#### 183rd session

## Proposal for the 09 series of amendment to UN Regulation No. 107 (M<sub>2</sub> and M<sub>3</sub> vehicles)

### Submitted by the Working Party on General Safety Provisions \*, \*\*

Model A

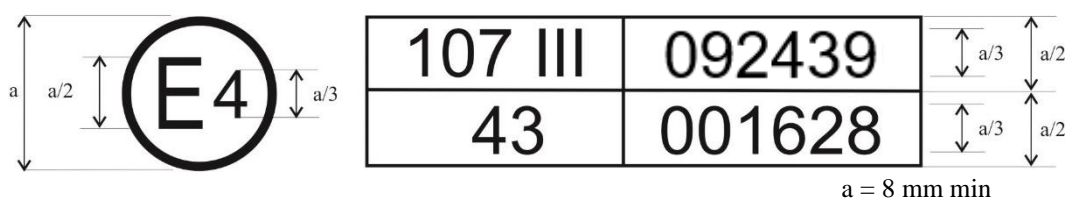
*Annex 2, amend to read:*

The above approval mark affixed to a vehicle shows that the vehicle type concerned has, with regard to its constructional features, been approved in the Netherlands (E 4) for Class III, pursuant to UN Regulation No. 107 under approval number 092439. The approval number indicates that the approval was granted according to the requirements of UN Regulation No. 107 as amended by the 09 series of amendments.
